**SECTION 00 90 01  
BIDDING AND CONTRACT REQUIREMENTS  
ADDENDUM NUMBER (6)**

Issued: May 3<sup>rd</sup>, 2024

**Re: ADDENDUM NUMBER (6) TO THE BIDDING DOCUMENTS FOR**

**Peoria Park District  
Golf Entertainment Facility Renovation an Addition  
Architect's Project Number: 22-051**

SHEET TITLE:  
**FIRST FLOOR PLAN - CLUBHOUSE - NEW SYSTEMS**

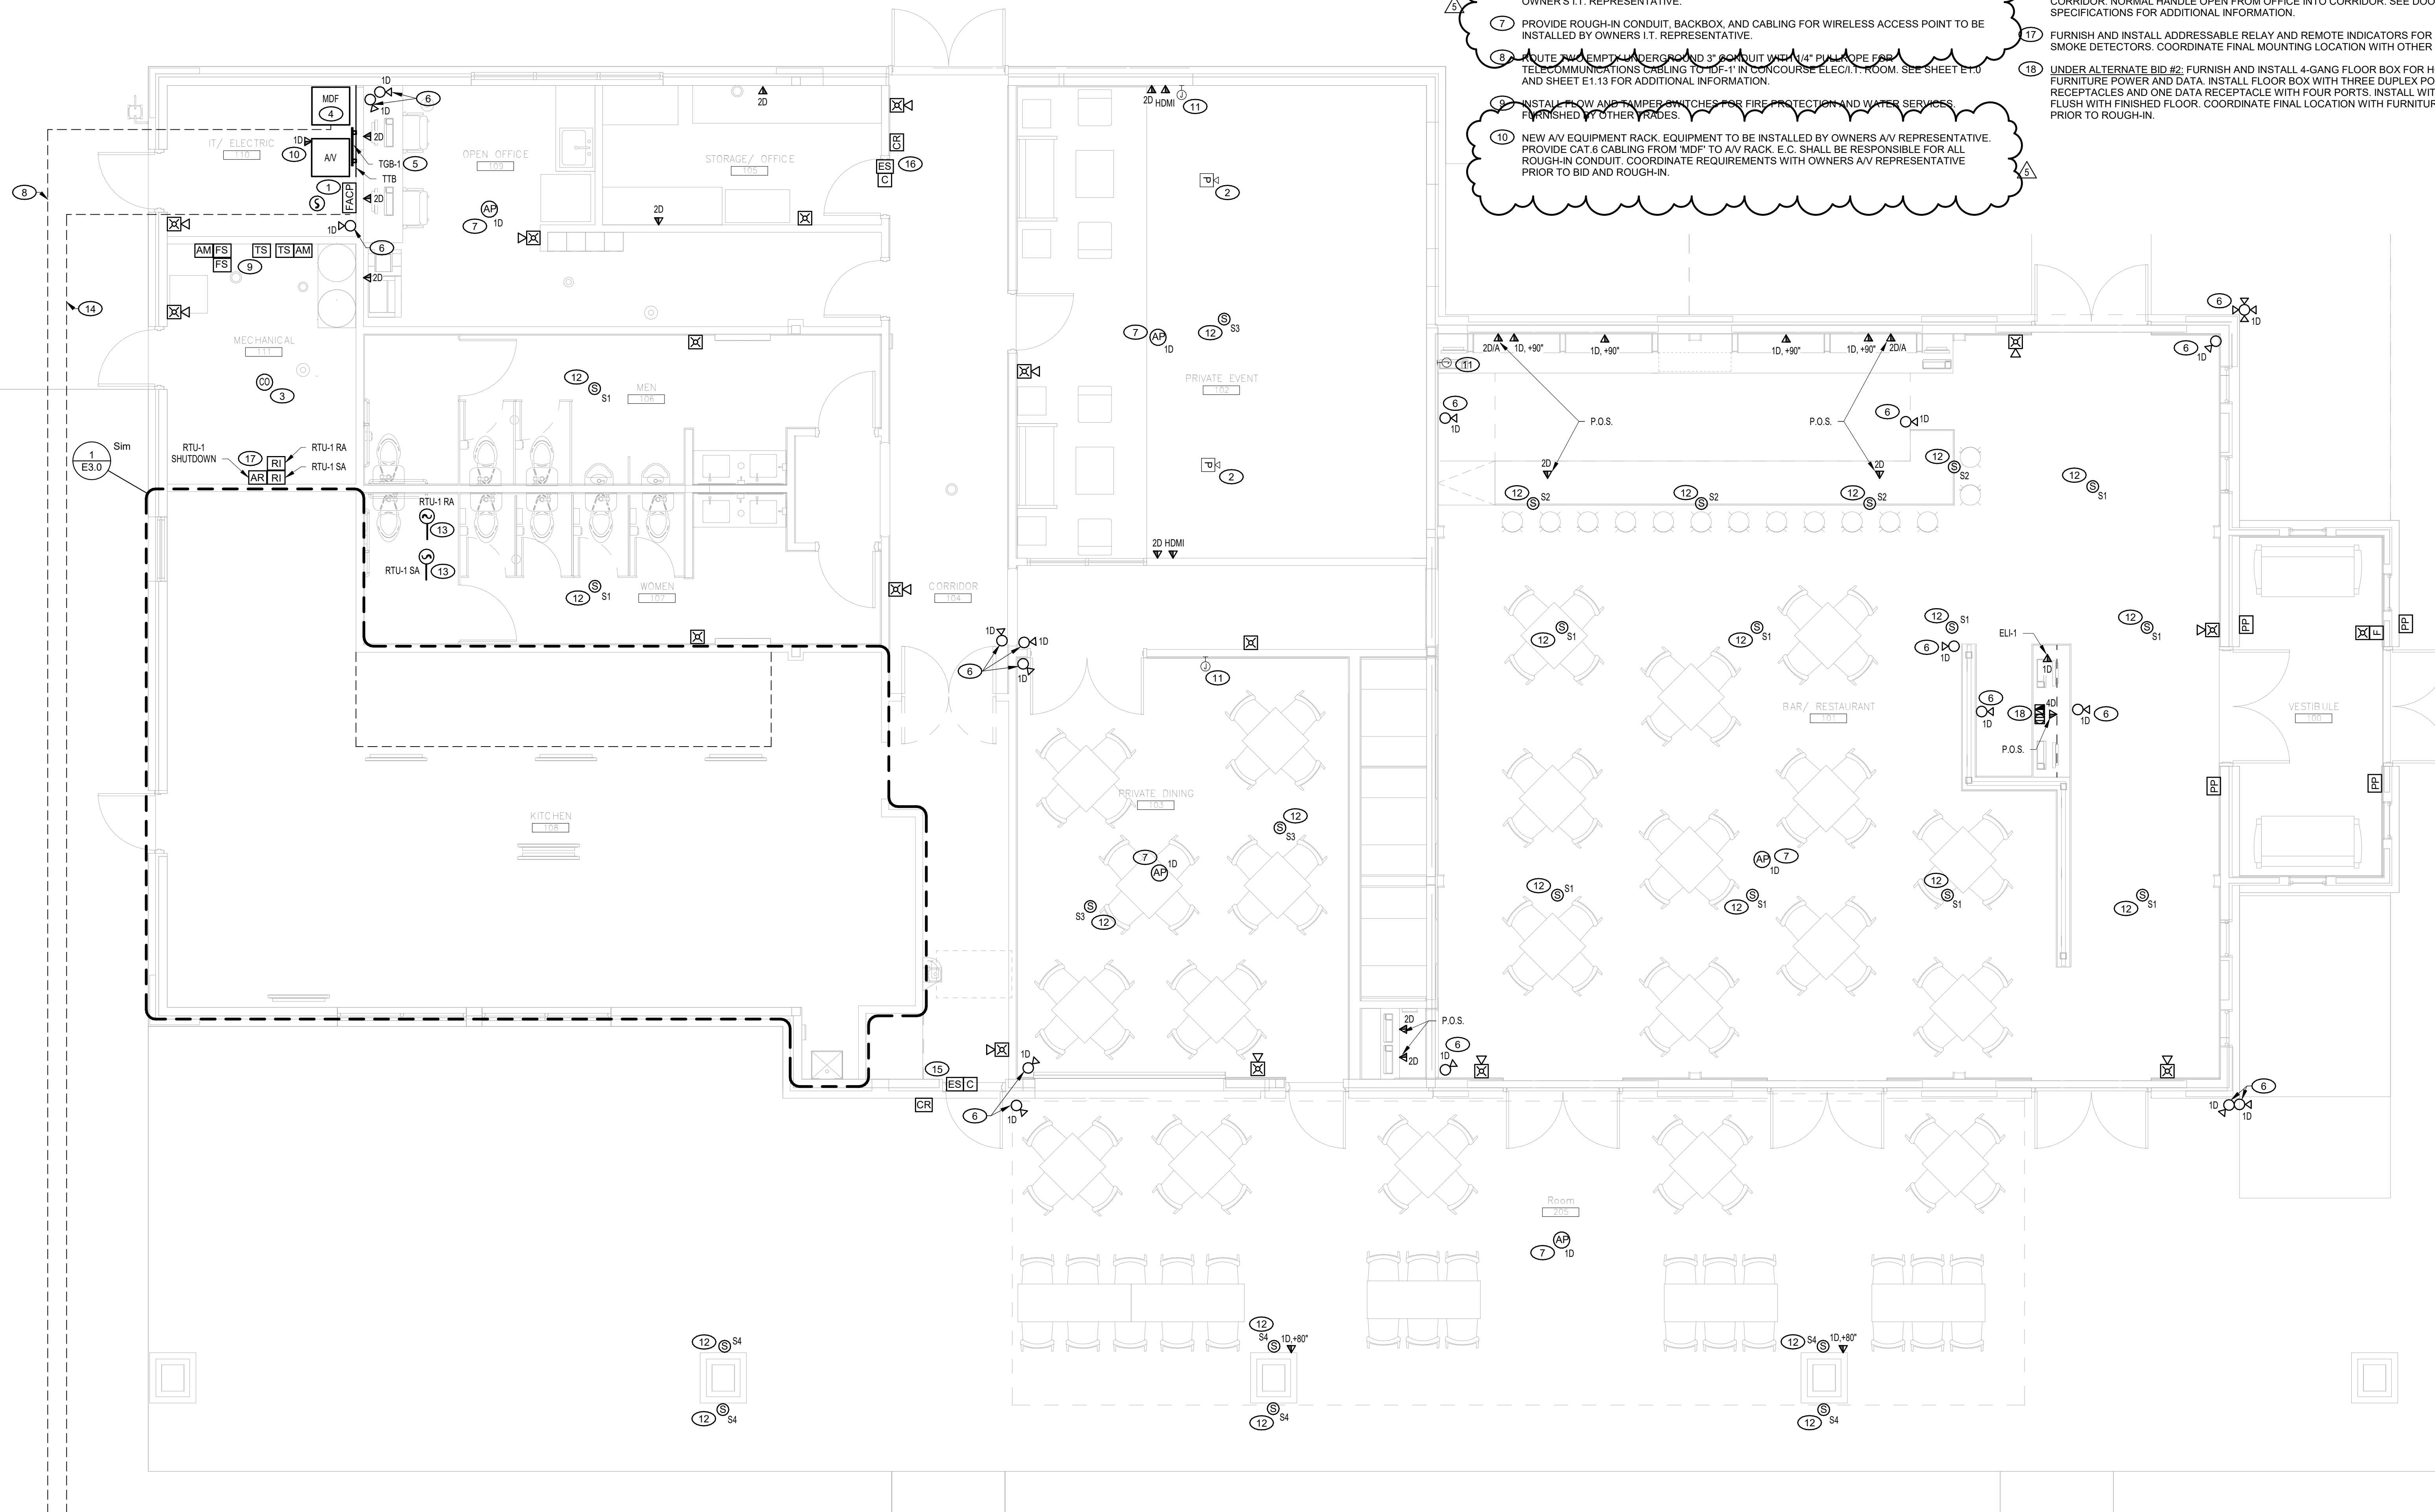
1. **E1.03 – FIRST FLOOR PLAN – CLUBHOUSE – NEW SYSTEMS**
  - a. Revised keyed notes #4, 6, 7, and 10 to clarify IT and A/V installations on drawings.
2. **E1.12 – FIRST FLOOR PLAN – RANGE BAYS – POWER**
  - a. Added keyed note #7 clarifying typical bay receptacle and installation requirements.
3. **E1.13 – FIRST FLOOR PLAN – RANGE BAYS – SYSTEMS**
  - a. Revise keyed note #1 for clarification of data cabling and rough-in installation at each bay.
  - b. Revise keyed note #2 to provide separate conduit runs for each bay mounted TV back to IDF-1.
  - c. Added keyed note #7 clarifying typical bay cabling and installation requirements.

E1.03 Note 10 says to coordinate with owner's A/V rep prior to bid. We don't have the information on who that is. Their A/V rep is an "in-house" team the Peoria Park District will use to order all equipment and A/V devices. Coordinate all A/V with Rebecca Fredrickson with the Park District. [rfredrickson@peoriaparks.org](mailto:rfredrickson@peoriaparks.org)

E1.03 Note 12 Install speakers. The note at the bottom of E1.03 says speakers installed by owner's A/V rep. E4.1 says speakers will be provided by owner's A/V rep and

**Door Hardware Spec 08 71 00 doesn't seem to match the doors shown on E1.03 that need access control. I'm seeing 105A, 109A and 108B that are not the same between the two. Please review. **The only access controlled doors shall be 105A and 108B. Both doors will have a card reader and electric strike. See revised electrical drawings.****

E1.03 I'm not seeing any fire alarm in the private event room 102 and Room 205. I checked with a fire alarm rep and they thought it may be required to have some kind of horn/strobe with the spaces being closed off. Please confirm. **Looks like the a/v notification for 102 got moved on the model. The A/V device in the corridor 104 that's by itself not on a wall is supposed to be in the private event room 102. As for office 105, yes, we should have a visual only device in that space.**

electrical is providing rough-in, but doesn't say who is installing. I want to confirm who is responsible for the installation. **The Park District will coordinate the installation of devices with their in house team.**

SHEET NUMBER:  
**E1.12**

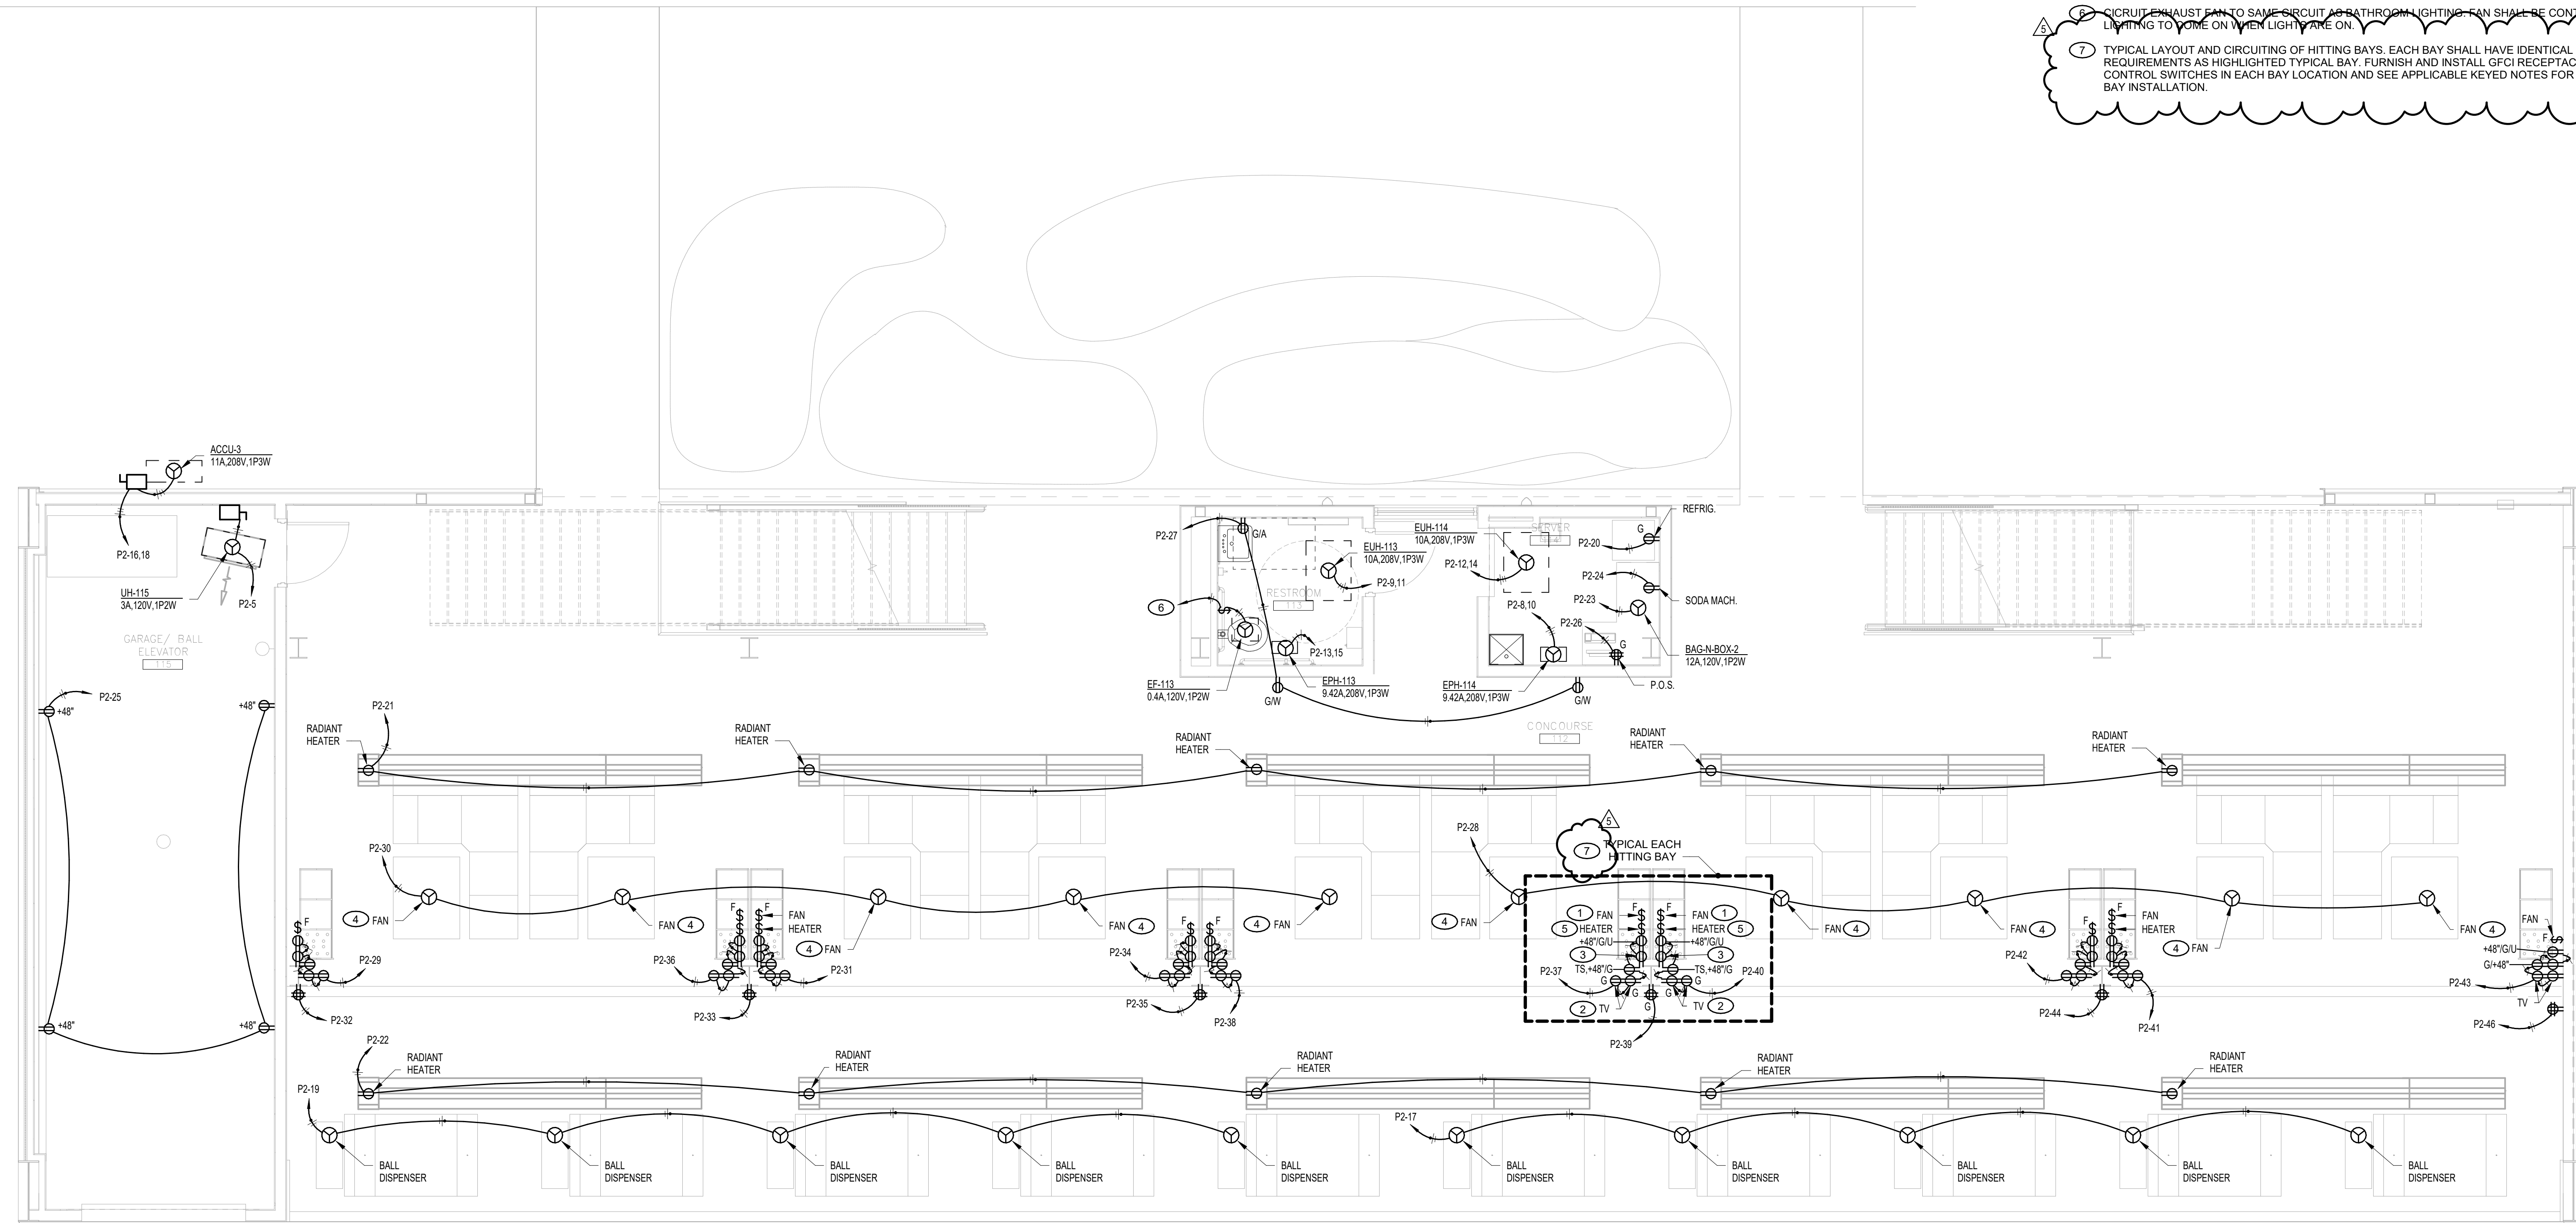
***E1.12 fan control notes say the fans are furnished by others. Will they be installing the fans or are we required to? Good question. Since no one else is calling out to furnish/ install, the E.C. shall be responsible for furnishing and installing the ceiling fans. They will need to coordinate final locations and mounting heights with architect..***

SHEET TITLE:  
**FIRST FLOOR PLAN -  
 RANGE BAYS -  
 SYSTEMS**

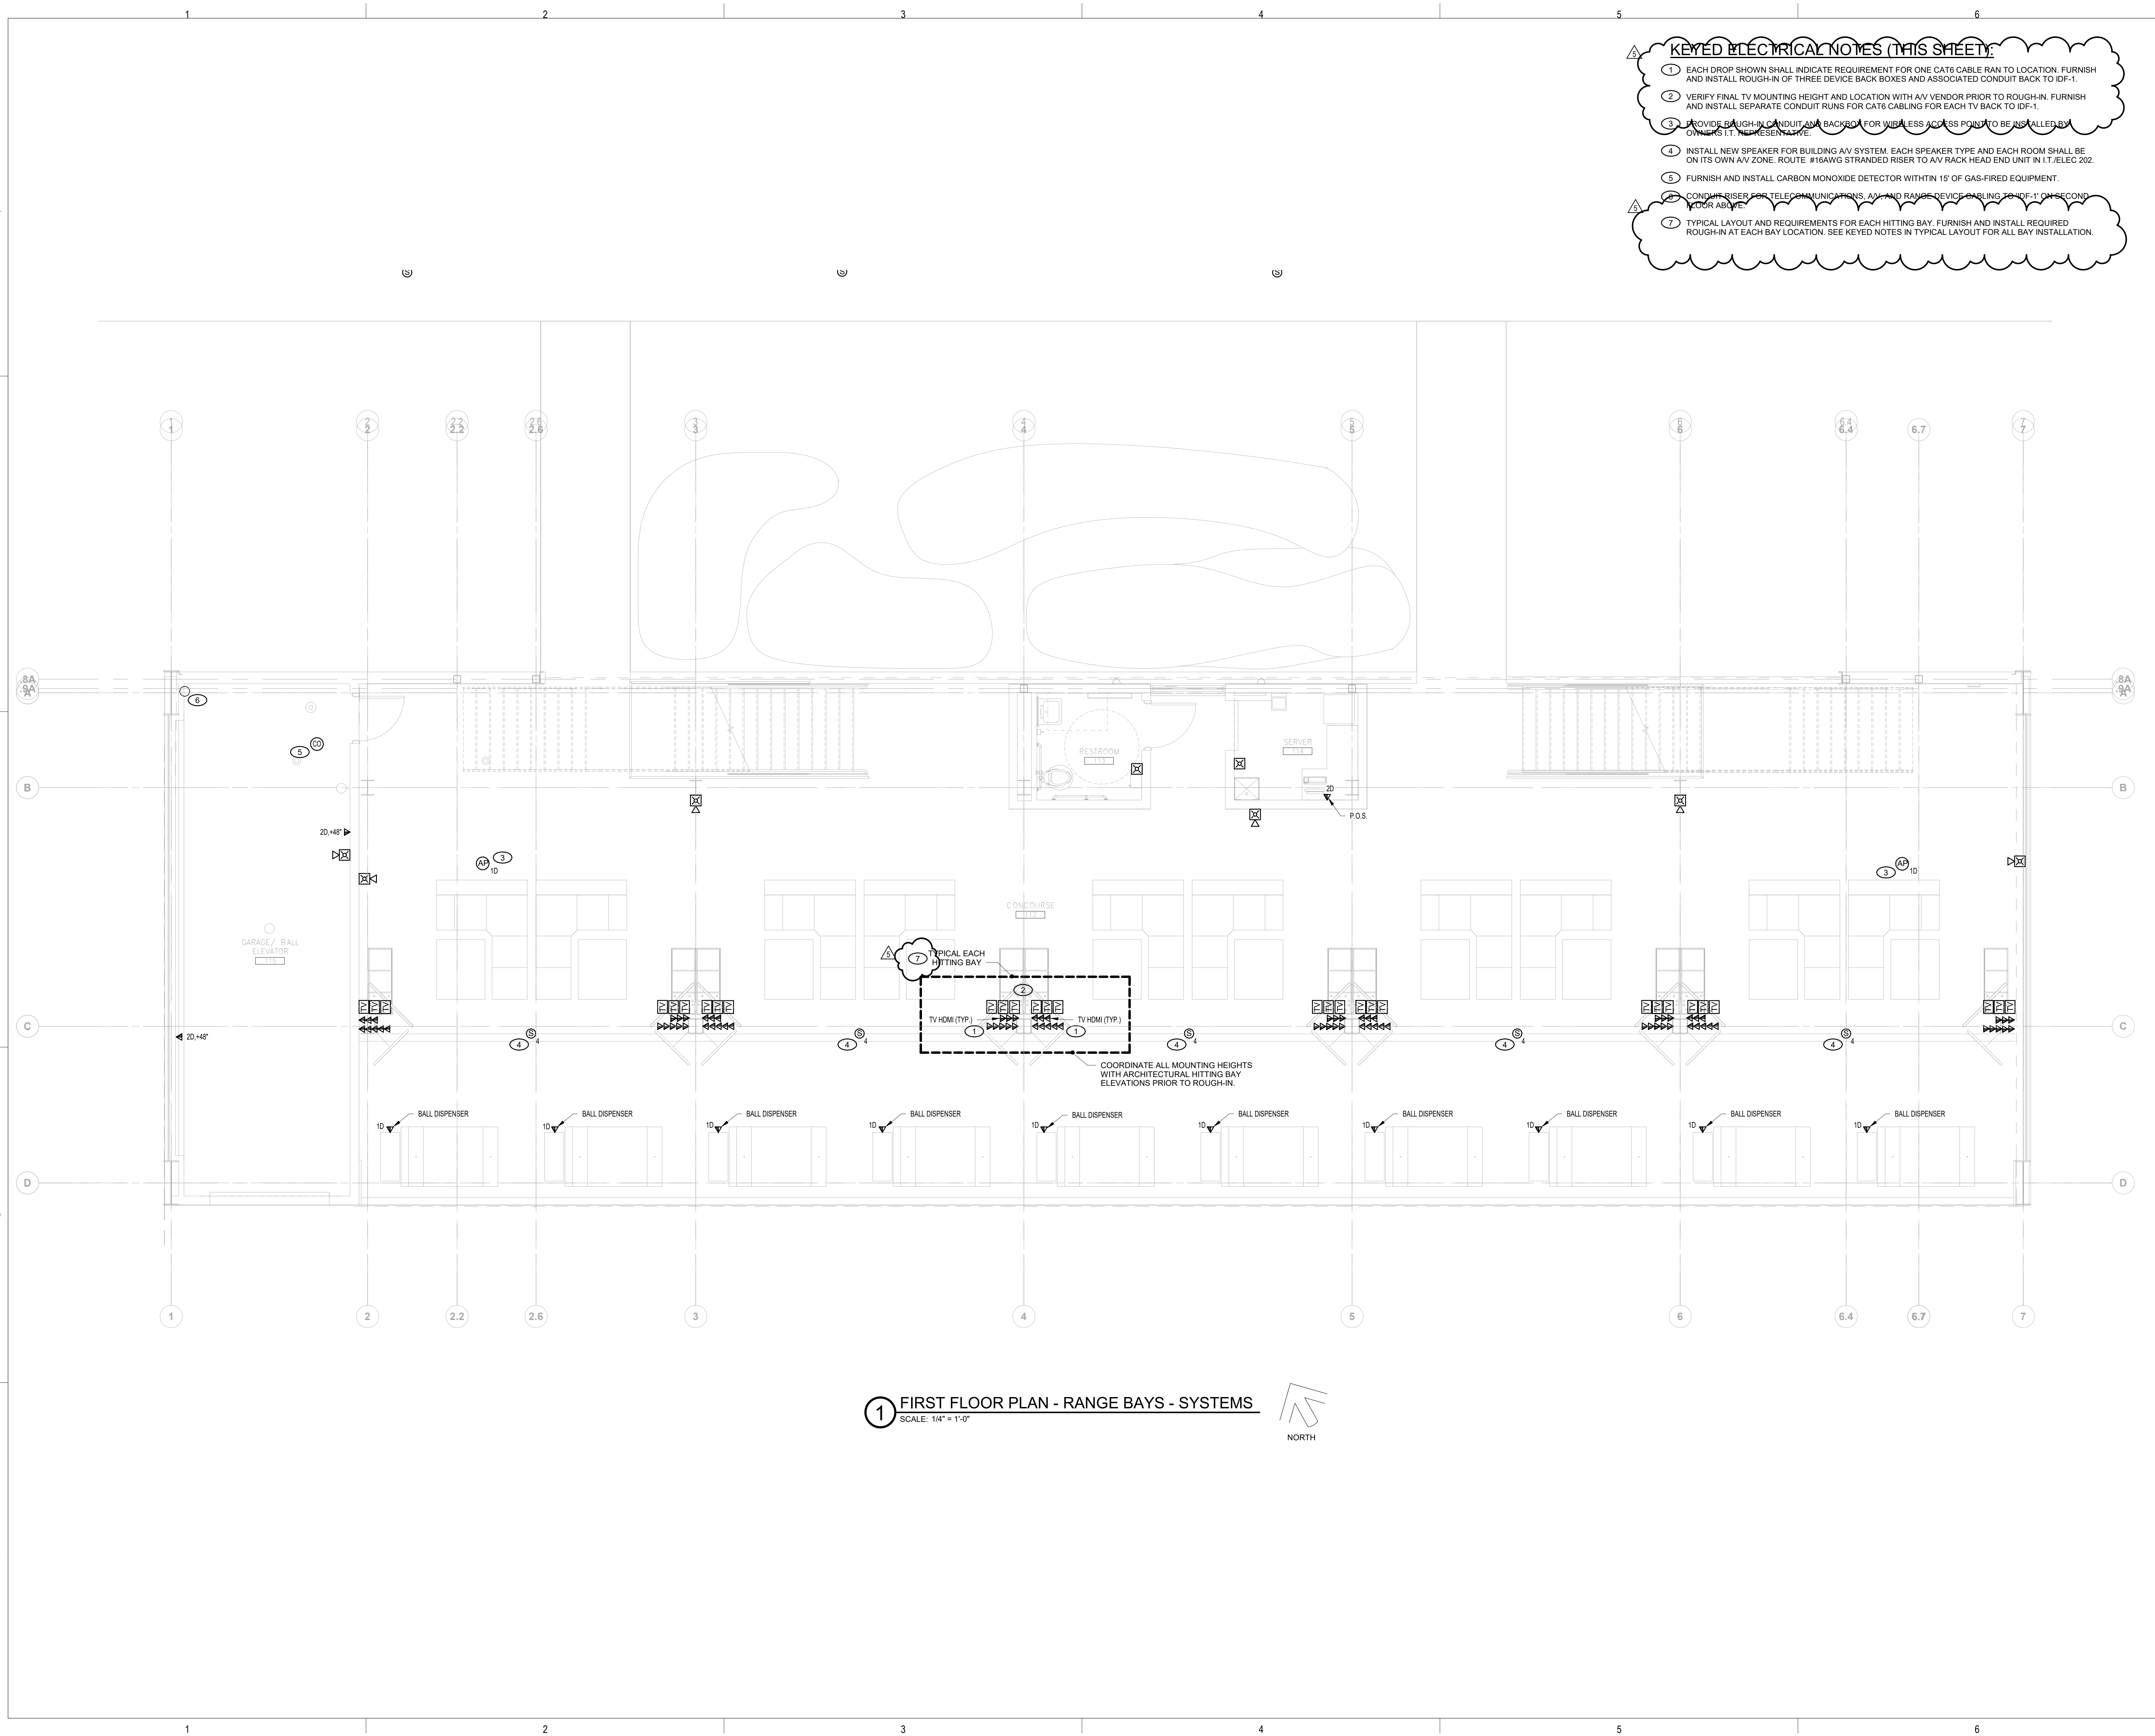
- a. Revise keyed note #1 for clarification of data cabling and rough-in installation at each bay.
  - b. Revise keyed note #2 to provide separate conduit runs for each bay mounted TV back to IDF-1.

- c. Added keyed note #7 clarifying typical bay cabling and installation requirements.
4. Drawing E1.22 – SECOND FLOOR PLAN – RANGE BAYS – POWER
  - a. Added keyed note #7 clarifying typical bay receptacle and installation requirements.
